HILLANDALE SECTION 2

ADMINISTRATIVE SUBDIVISION PLAN NO. 620190070

Request to adjust a lot line to create one net new buildable lot and bring one existing single-family dwelling into zoning conformance.

No. 620190070

FIRE HEIGHT RESTRICTED - SINGLE FAMILY DETACHED HOME DETAIL

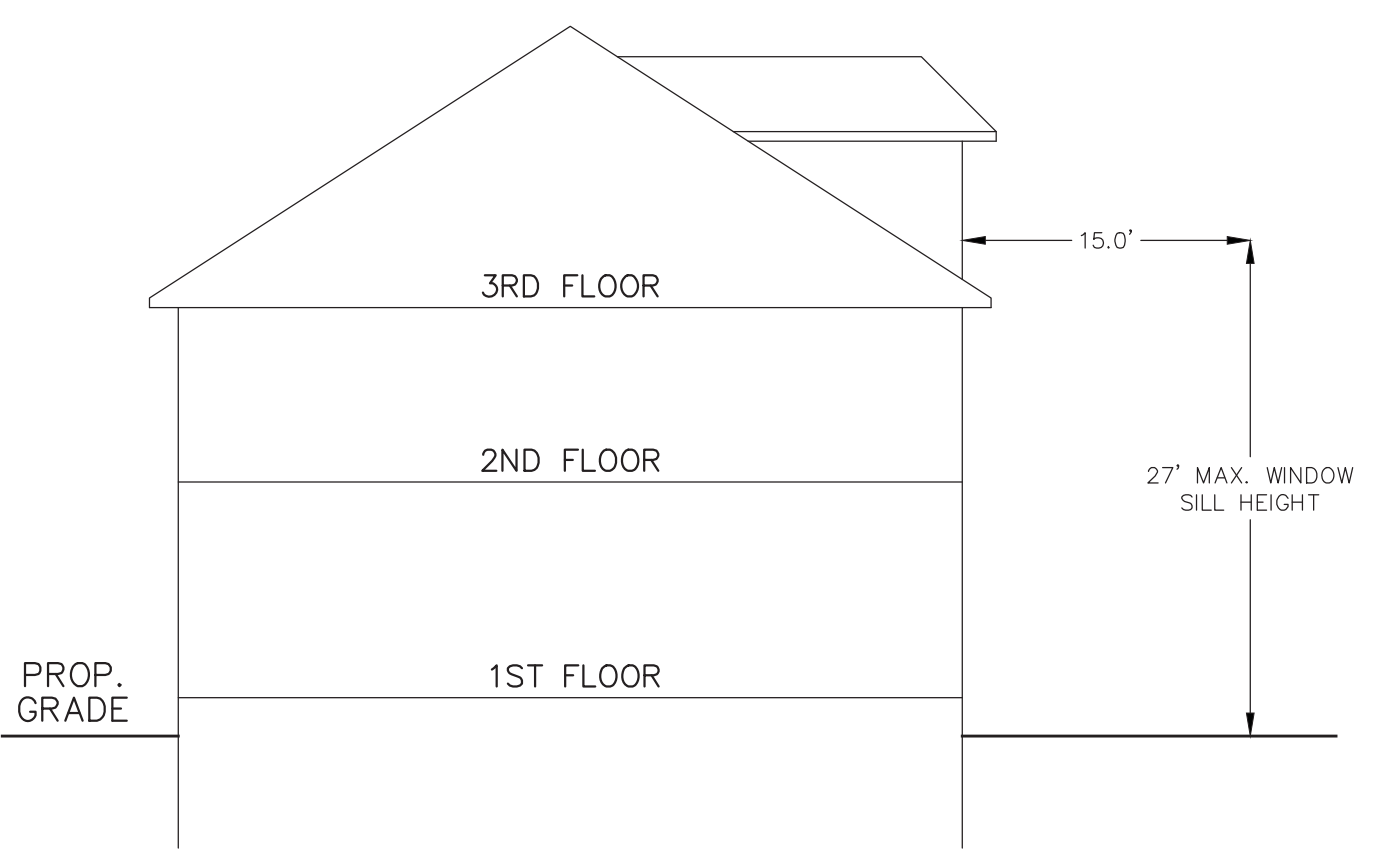
* PROPOSED HOUSES ARE SUBJECT TO HEIGHT RESTRICTIONS WHERE THE MAXIMUM WINDOW HEIGHT ON THE 3RD FLOOR (OR UPPER HALF STORY) IS LIMITED TO 27-FEET ABOVE GRADE, AS MEASURED 15-FT FROM THE HOUSE. (SEE DETAIL THIS SHEET)

* A FD ACCESS AMENDMENT, ELIMINATING THE ABOVE HEIGHT RESTRICTION, MAY BE SUBMITTED TO MCDPS FOR APPROVAL IF PROPOSED HOUSES ARE 15-FT OR MORE FROM RESPECTIVE PROPERTY LINES (30-FT APART).
